# RFP 00335211

## Questions and Answers

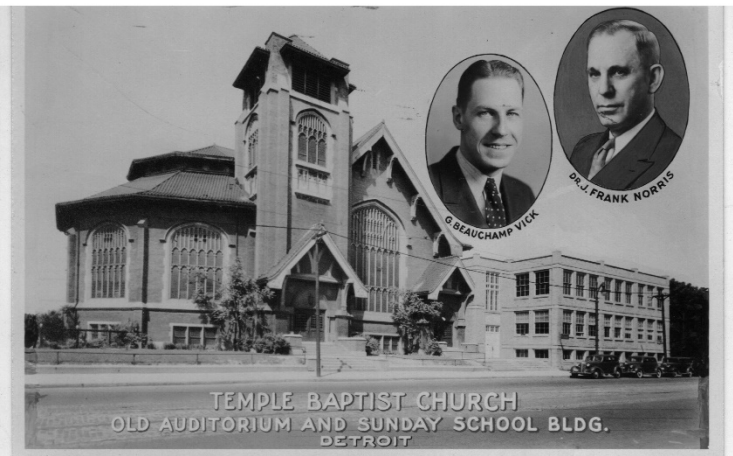
*Question 1: Attached is a postcard (from the private collection of Mike McCleer, architect) of the King Solomon Baptist Church prior to the construction of the south addition. It shows a (clay) tile roof on the original church structure. Will a new roof of (clay) tile be required for this structure?*

*Question 2: The postcard also shows the details of two roof levels of the church's original half-round wing. This half-round wing was swallowed up by the later South addition, which also blocks what is left of this roof from being seen from the sidewalk. Will a rebuilding of this roof's original structure and detailing be required?*

**Answer 1: No. Architecture asphalt shingle will be installed.**

**Answer 2: The roof structure shown in the postcard is largely intact and is referred to in the RFP as the Central core steep slope roof. There is a high probability that some of the structural members of the sanctuary roof will need to be repaired and or strengthened as a part of the overall roofing project. The design consultant will be responsible for recommending the extent of needed repairs.**
